TO: Service Locations

FROM: Technical Service

SUBJECT: **MBE4000 Cylinder Head And Head Gasket Information**

Figure 1 – MBE4000 Cylinder Head Recess and Head Gasket Grommet

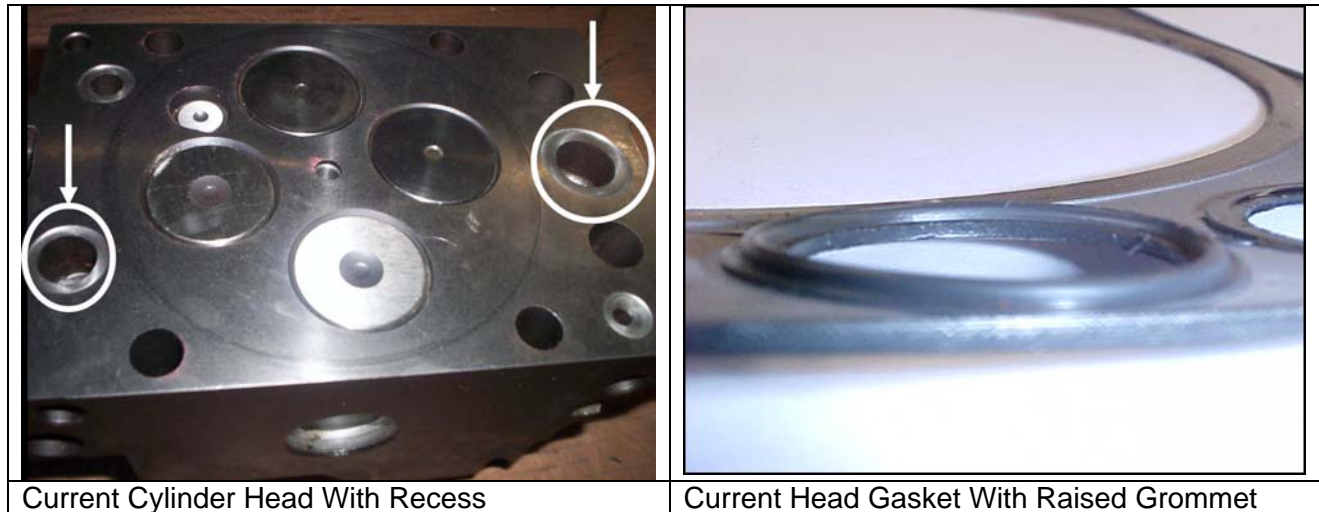
A recessed grommet sealing area was machined around each coolant inlet and outlet port in the cylinder head to give a better mating surface for the thicker rubber seal in the head gasket. See Figure 1. The new cylinder head and gasket became effective with engine S/N: 0460866443 built on August 1, 2006.

- Grommet style cylinder heads and gaskets **MUST** be used together on the same cylinder. Do NOT mix grommet and non-grommet style cylinder heads and gaskets on the same cylinder.
- Grommet and non-grommet style cylinder heads and gaskets can be used in the same engine provided they are matched as noted above. Do NOT replace all six cylinder heads and gaskets simply to have all the same new parts on the engine.
- Reference Technical Service letter 09 TS-9 for more information.

Figure 2 – MBE4000 Cylinder Head Cup Plug

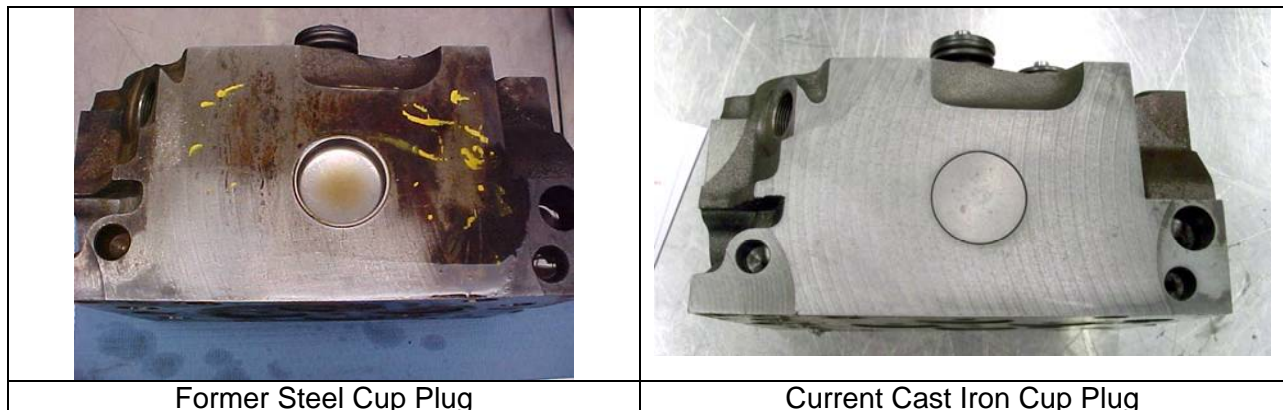
Further improvements to the cylinder head is a change to a cast iron cup plug instead of a steel cup plug to prevent head cracking. See Figure 2. The new cylinder head became effective with engine S/N: 0460884866 built on April 25th, 2007.

Figure 3 – MBE4000 Cylinder Head Gasket Vent Gap

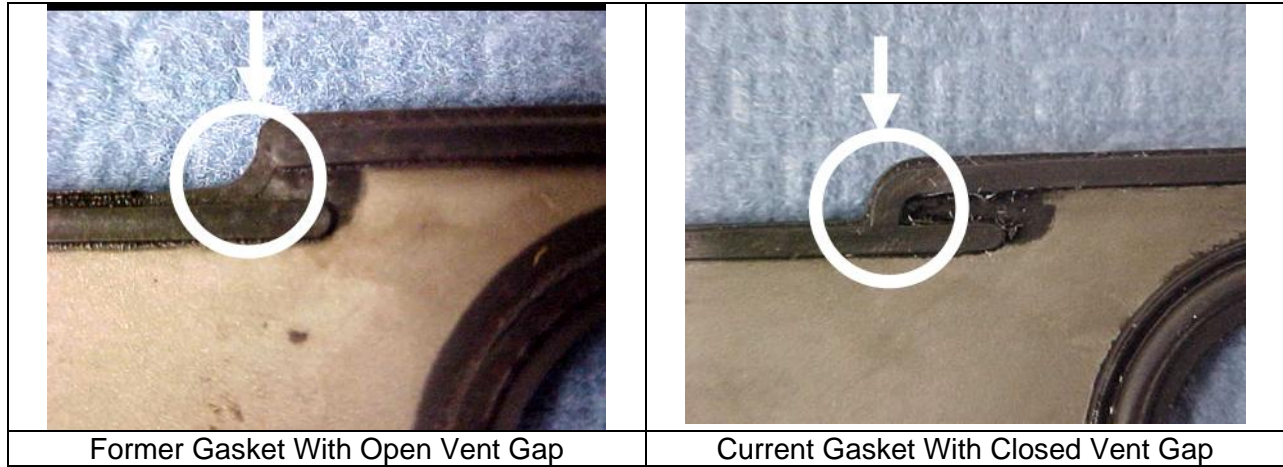
Another improvement to the head gasket includes the removal of the vent gap around the perimeter of the gasket. This will prevent water intrusion under the gasket which can cause rusting and pitting of the fire deck surfaces of the cylinder block and head, but ultimately does not affect the sealing surfaces. See Figure 3. The new cylinder head gasket became effective with engine S/N: 0460896913 built on September 3rd, 2007.
